This version was included in Mr Glossop's Town Planning Expert Report produced for DHHS at the request of the Standing Advisory Committee and distributed October 30. While it is clearly an Appendix and not intended to be understood as the DPO Schedule itself it adds to the confusion around document navigation, particularly for stakeholders from non-planning backgrounds.

## **APPENDIX F: TRACK CHANGES COPY OF PROPOSED DPO**

## SCHEDULE 3 TO CLAUSE 43.04 DEVELOPMENT PLAN OVERLAY

### PUBLIC HOUSING RENEWAL - NEW STREET, BRIGHTON

[Development Concept Plan](#)

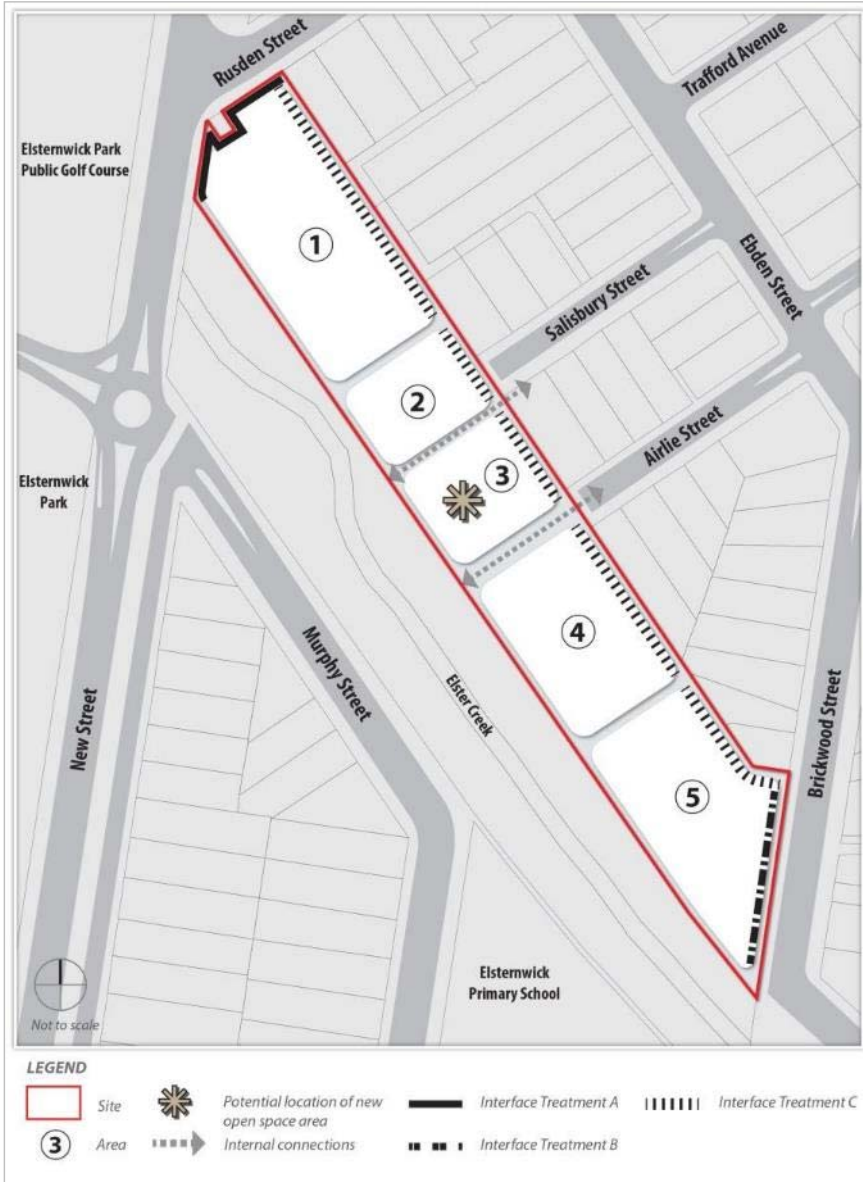
**Commented [JG5]:** Preferale that heights be expressed in metres (m) but with the number of stroeys listed underneath in brackets.

**Commented [JG6]** recommend an interface treatment be prepared for Elster Creek boundary.

Also recommend that further consideration be given to ~~limit~~ at the north east corner of the site with Rusden and New Street and south east corner with Brickwood Street.
